## MEMORANDUM

<b>SITE:</b>	Biddlestone Farm, Llangarron, Ross-On-Wye, Herefordshire, HR9 6NT
<b>APPLICATION TYPE:</b>	Planning Permission
<b>DESCRIPTION:</b>	Erection of up to 32 hectares of fixed (non-rotated) 'Spanish' polytunnels over arable (soft fruit) crops grown on 'table tops'.
<b>APPLICATION NO:</b>	173774
<b>GRID REFERENCE:</b>	OS 353986, 223221
<b>APPLICANT:</b>	Mr Mark Green
<b>PARISH:</b>	Llangarron

*(Included for illustrative purposes only – not to scale)*

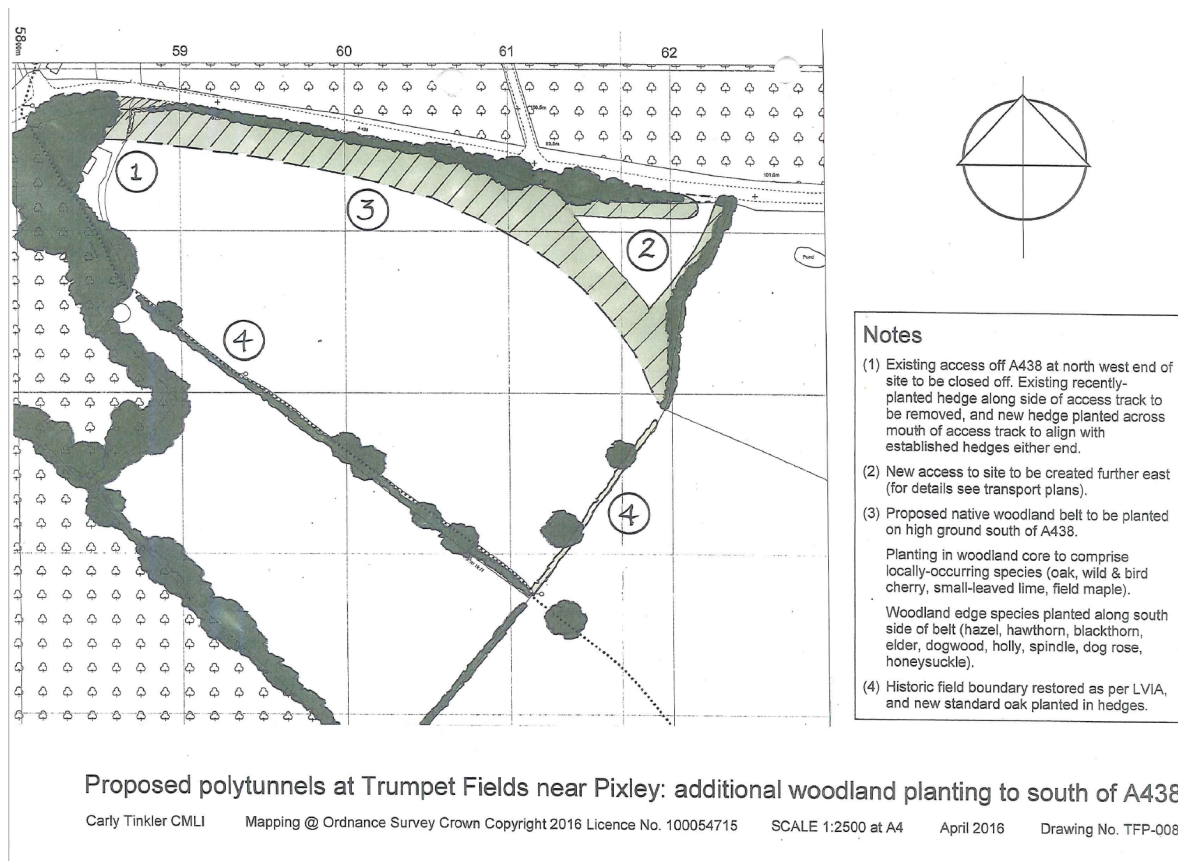
- 7.11 Overall, in its current format I do not think that the scheme has properly assessed the extent and nature of the harms, specifically to adjacent receptors, to a point where I must conclude that the scheme is not acceptable in its current format and should not be supported.
- 7.12 Having said that, given that the perimeter areas of the site slope up or down to a central plateau, then I can see that it would be possible to improve the containment of the site to an acceptable level by planting a buffer zone in locations where it would provide important screening. A scheme should be developed (similar to the diagram below) to provide a more substantial scheme of planting (e.g. strategic landscape / woodland belts of 20 m- 30 m in width).

- 7.13 Any proposed planting must be developed to reflect the wider character of the landscape and in line with aims and aspirations of the Herefordshire LCA. It must not be that this planting is itself viewed as an alien feature in the landscape.

- 7.14 The full extent of the new planting might be adjusted to take full account of the exact location of new ponds and depth / quality of existing vegetation in specific locations. This could even include off-site planting where ownership allows
- 7.15 This must also be allied to a long-term management strategy which includes a program for removing the inappropriate conifer and single species hedging and replacing them with native hedgerows. These hedgerows must be set within an appropriately sized 'exclusion' zone.
- 7.16 Whilst this would not remove all the harmful views, it would reduce the more harmful and, most importantly, help to provide significant habitat offset (benefit) and add much improved GI connectivity and habitat value.
